STAUNTON HISTORIC PRESERVATION COMMISSION**February 5, 2026****12:00 p.m.****Council Chambers**

STAUNTON HISTORIC PRESERVATION COMMISSION

815 West Beverley Street

Install Screen for Side Porch

815 W. BEVERLEY ST EXISTING PORCH
NORTH ELEVATION TO BE SCREENED
NOT VISIBLE FROM STREET

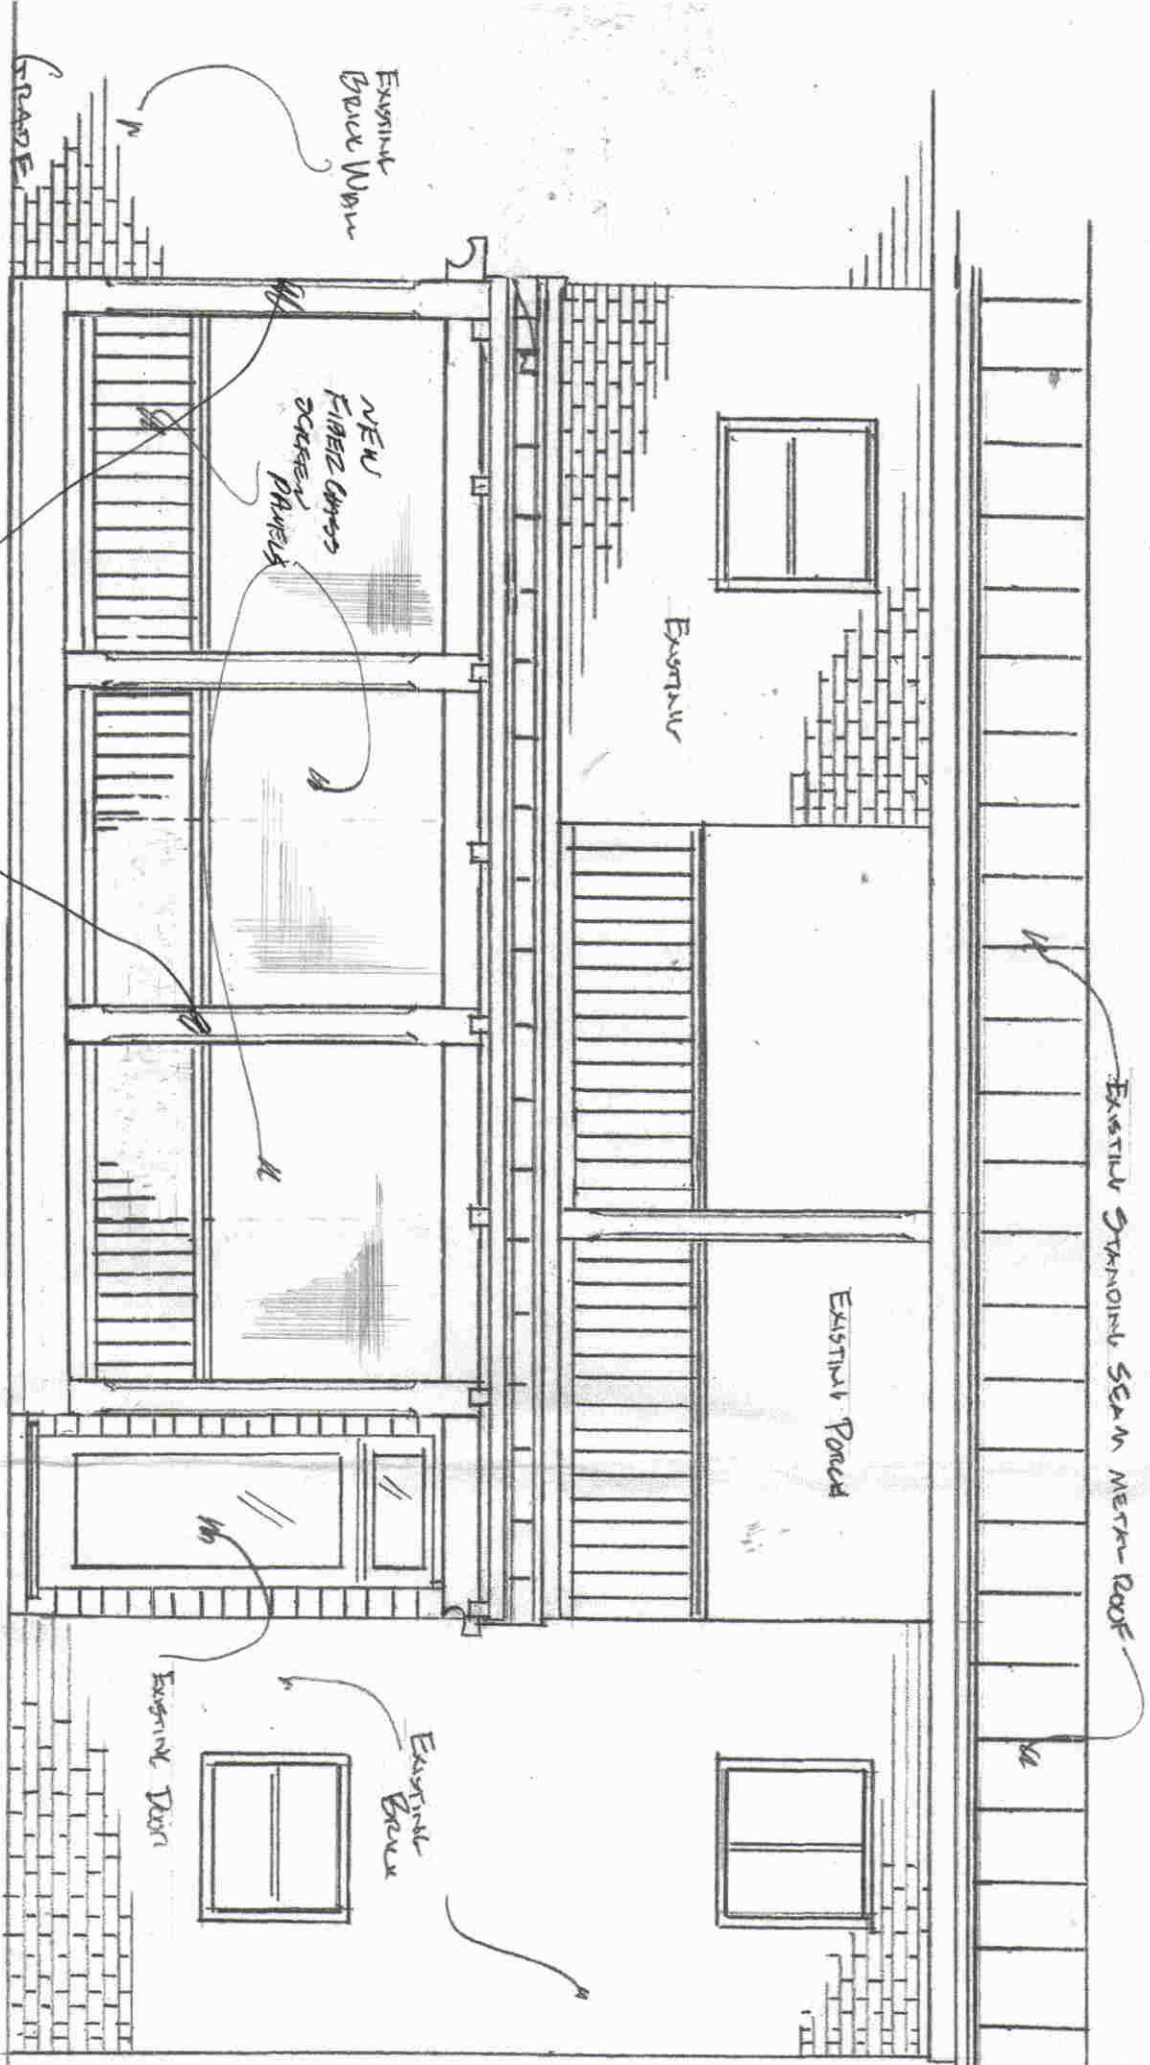
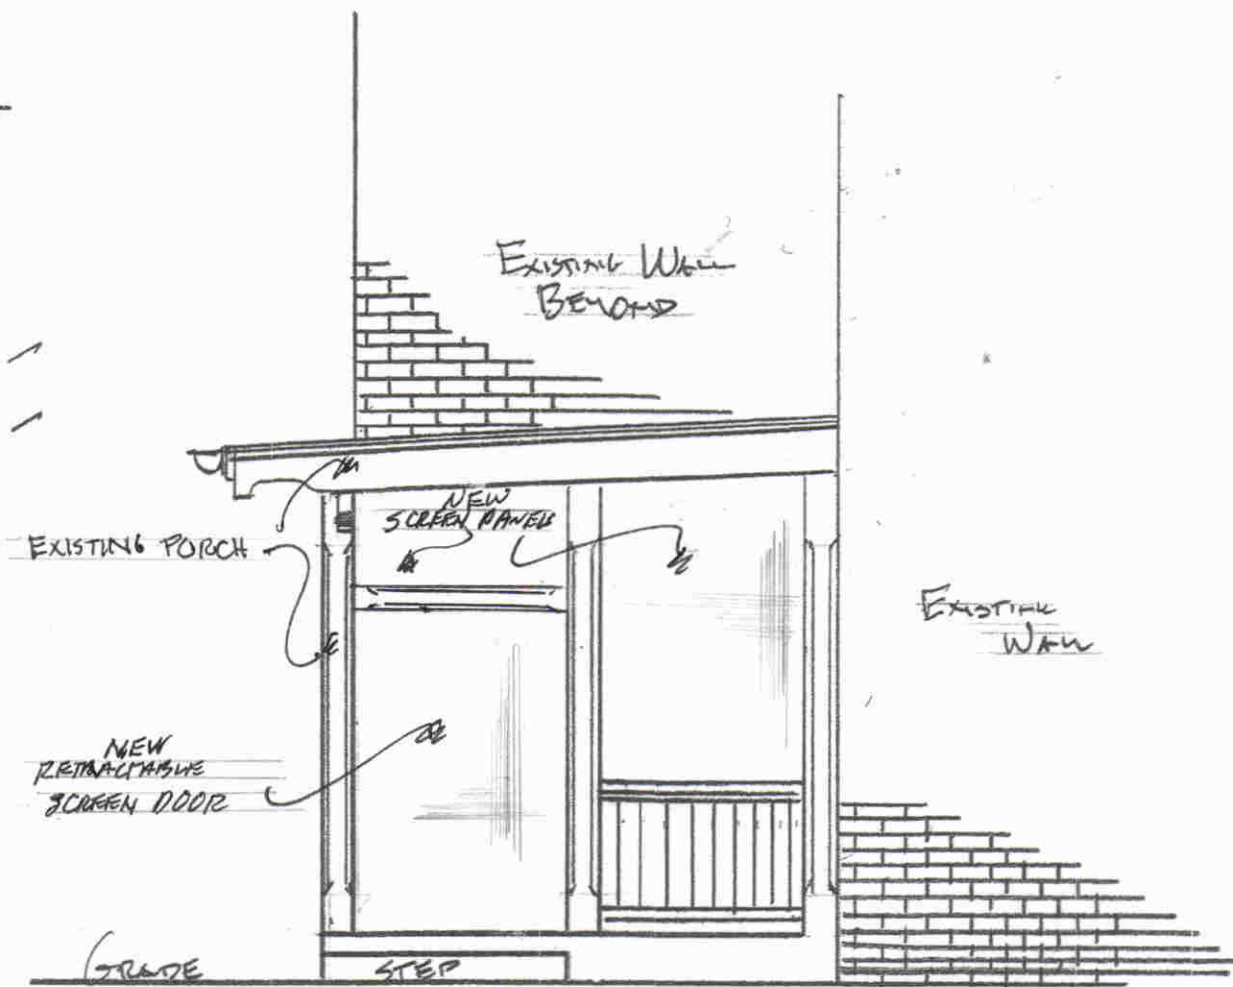
HSF Recommendation: HSF recommends the certificate of appropriateness be approved. The porch is located at the side and toward the rear of the house with limited view. The treatment does not enclose the porch and will not alter the size, scale, or materials of the porch.

Mr. Brown made a motion to approve the Certificate of Appropriateness at 815 W. Beverley Street as submitted. The porch shall be located at the side and toward the rear of the house with limited view. The treatment shall not enclose the porch and will not alter the size, scale, or materials of the porch.
